HIGHWAY 24 EASTGATE BUSINESS PARK

A CONDOMINIUM PLAT OF LOT 3, HILLCREST ACRES

BUILDING NO. 5

Plat Drawing_V1.pdf Markup Summary

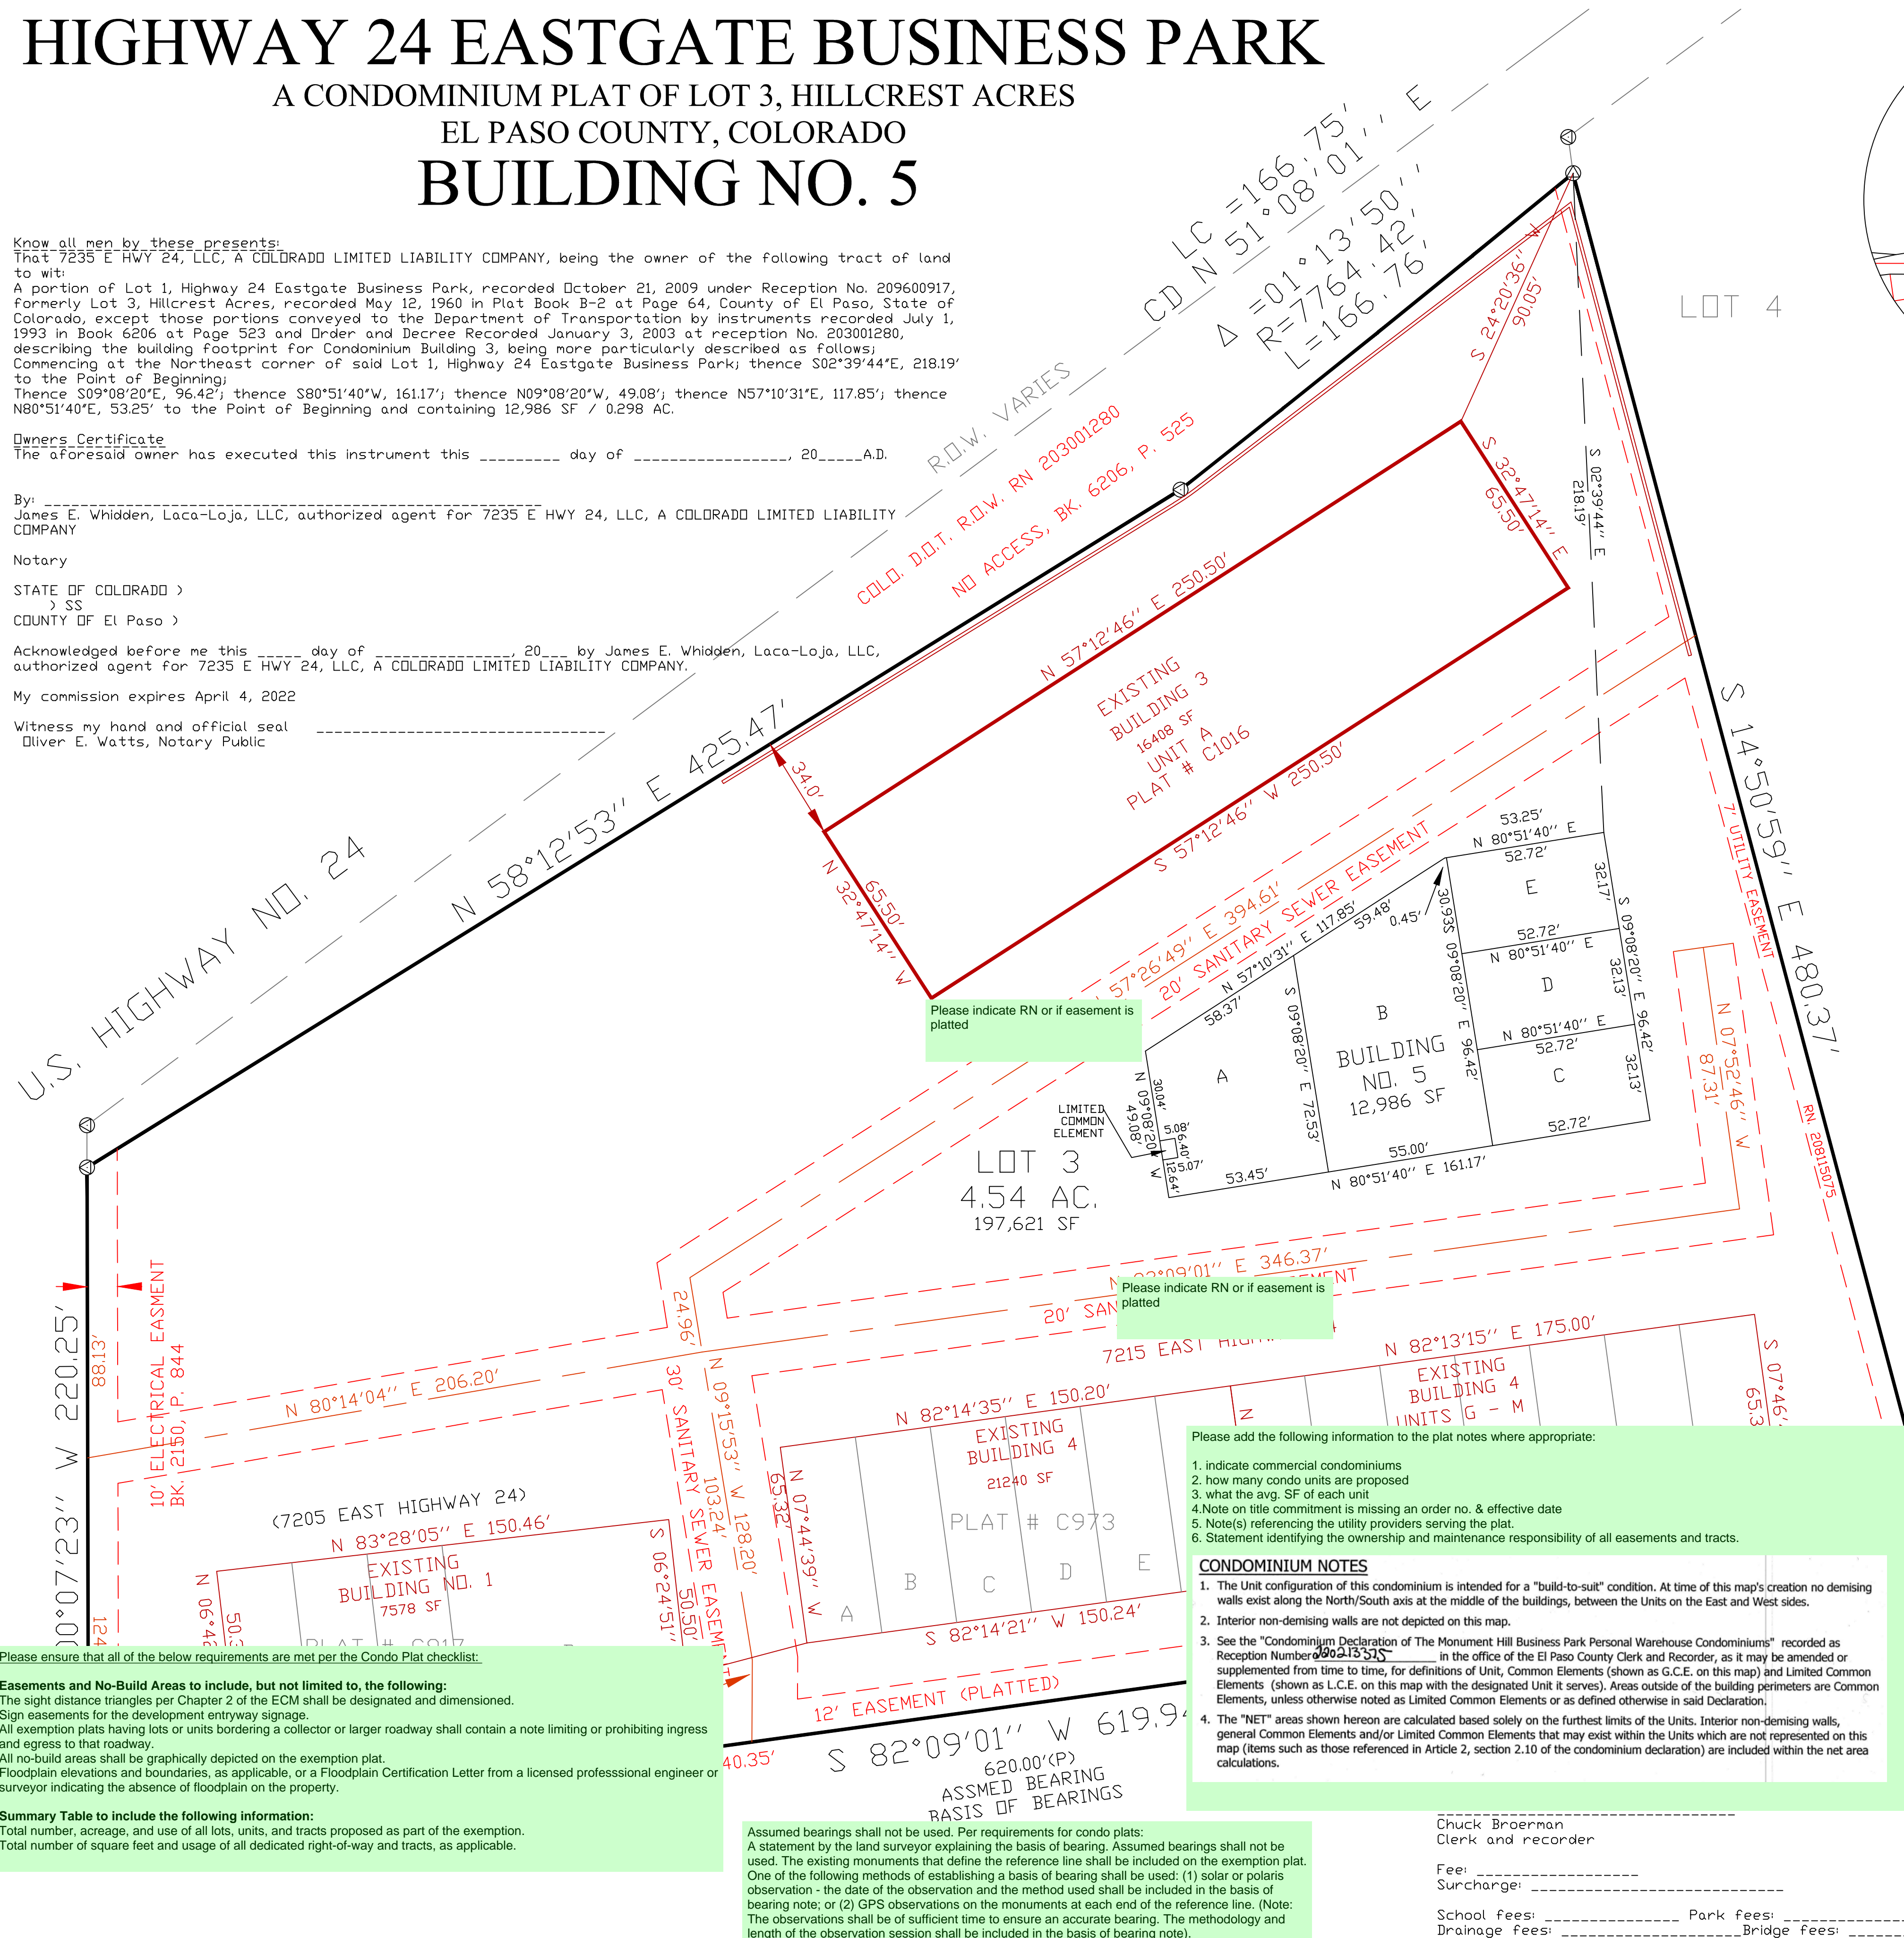
Please indicate RN or if easement is platted

Please indicate RN or if easement is platted

edge

Building No. 5
